**DEPARTMENT OF TRANSPORTATION
STATE OF GEORGIA**

Muscogee County
GDOT District 3 - Thomaston
SRTS - Clubview Elementary School

SUBJECT APPROVED REVISED CONCEPT REPORT

**DEPARTMENT OF TRANSPORTATION
STATE OF GEORGIA
REVISED PROJECT CONCEPT REPORT**

PROJECT LOCATION:

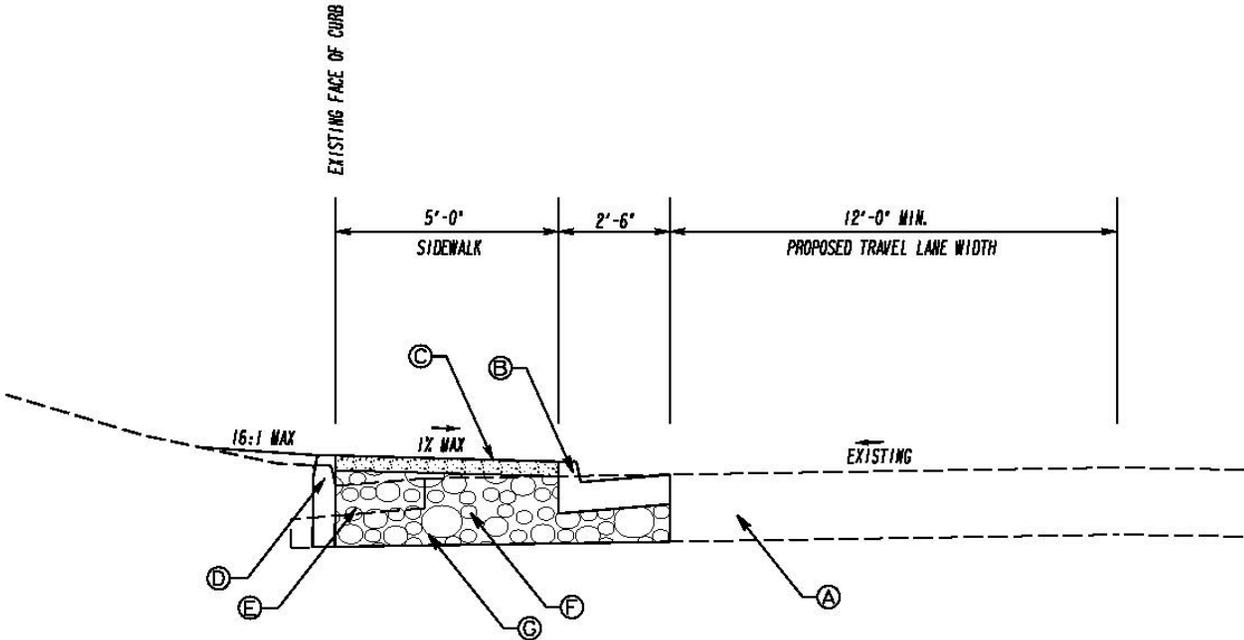
Approved Features:	Proposed Features:
<p>Project Termini: The approved features consist of ADA-compliant improvements (sidewalks, crosswalks and appropriate signage) to facilitate student pedestrian travel to and from Clubview Elementary. All improvements would be constructed within existing right-of-way at the following locations:</p> <ul style="list-style-type: none"> • Clubview Drive, from Lynda Lane and Nancy Street (approximately 612 feet long) • Lynda Lane, from Clubview Drive to Sue Mack Drive (approximately 972 feet long) • Sue Mack Drive, from Lynda Lane to Edgewood Road (approximately 1,430 feet long) <p>Improvements would include where appropriate the installation of 5 foot sidewalks, curb-cut sidewalk ramps, crosswalks, and signage.</p>	<p>Project Termini: The proposed revision would consist of removing the previously approved ADA-compliant pedestrian improvements at the following locations:</p> <ul style="list-style-type: none"> • Clubview Drive, from Lynda Lane and Nancy Street (approximately 612 feet long) • Lynda Lane, from Clubview Drive to Sue Mack Drive (approximately 972 feet long) • Sue Mack Drive, from Lynda Lane to Nancy Street (approximately 714 feet long) <p>The previously approved ADA-compliant pedestrian improvements would remain at the following location:</p> <ul style="list-style-type: none"> • Sue Mack Drive, from Nancy Street to Edgewood Road (approximately 716 feet long)

<p>Reason(s) for change: Request from project sponsor to reduce project scope/termini.</p>
